DEPARTMENT OF PUBLIC WORKS COUNTY OF HUMBOLDT

LAND **USE DIVISION INTEROFFICE MEMORANDUM**

- RE: SUBDIVISION REOUIREMENTS - IN THE MATTER OF THE SANTOS. APPLICATION # PLN-2022-17486 FMS, APN 508-391-045, FOR APPROVAL OF A TENTATIVE MAP, CONSISTING OF 10.51 ACRES INTO 45 LOTS
- DATE: 11/28/2022

These recommendations are based on the tentative map prepared by Schillinger Engineering dated July 8, 2022 and dated as received by the Humboldt County Planning Division on July 13, 2022.

Above: google aerial image with proposed improvements to McKinleyville Avenue shown in red

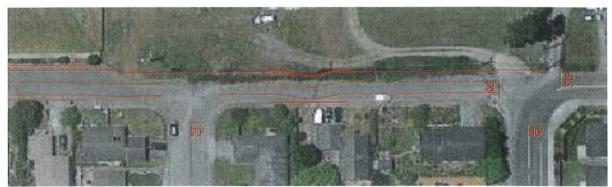
• From the north line of Lot 59 of Tract No. 644 to the north line of Lot 56 of Tract No. 644, the road shall be signed and striped for bike lanes; and shall be striped with a centerline stripe. The curb shall be painted red for no parking on the west side of the road; a parking lane shall be provided on the east side of the road.

Install street trees symmetrically along the road (i.e., trees on left and right sides of the road at same Station); roughly, one (1) tree per lot. Applies only to the lots in Tract No. 644 that abut McKinleyville Avenue. Note: Lot 59 is developed with curb adjacent sidewalk; no landscape strip or trees will be planted along the frontage of Lot 59.

- From the north line of Lot 56 of Tract No. 644 to Washington Avenue shall be widened to provide two 11 foot wide travel lanes; and one 8 foot wide parking lane on the east side. The road shall be posted with no parking signs along the west side.
- Construct a temporary chicane at the existing utility pole north of Ian Lane. The road shall be widened at the chicane to provide a 2 foot wide paved shoulder on the west side. Along the chicane, construct an AC dike on the west side of the road.

Along the east side of the chicane, a no parking zone shall be painted on the existing curb; the AC dike shall also be painted red.

The chicane is to be removed when APN 508-232-004 or APN 508-341-050 constructs their frontage improvements, and the utility pole is removed.

- Install a stop sign, limit line, and stop pavement marking on west bound Ian Lane at its intersection with McKinleyville Avenue.
- Install a three way stop (including stop signs, limit lines and stop pavement markings) at the intersection of Washington Avenue and McKinleyville Avenue. Remove conflicting signing and striping as necessary.
- The barricade located at the northerly line of Lot 59 (on the east) [APN 508-391-029-000] of Tract No. 644 shall be removed at the time that McKinleyville is constructed between School Road and Washington Avenue.
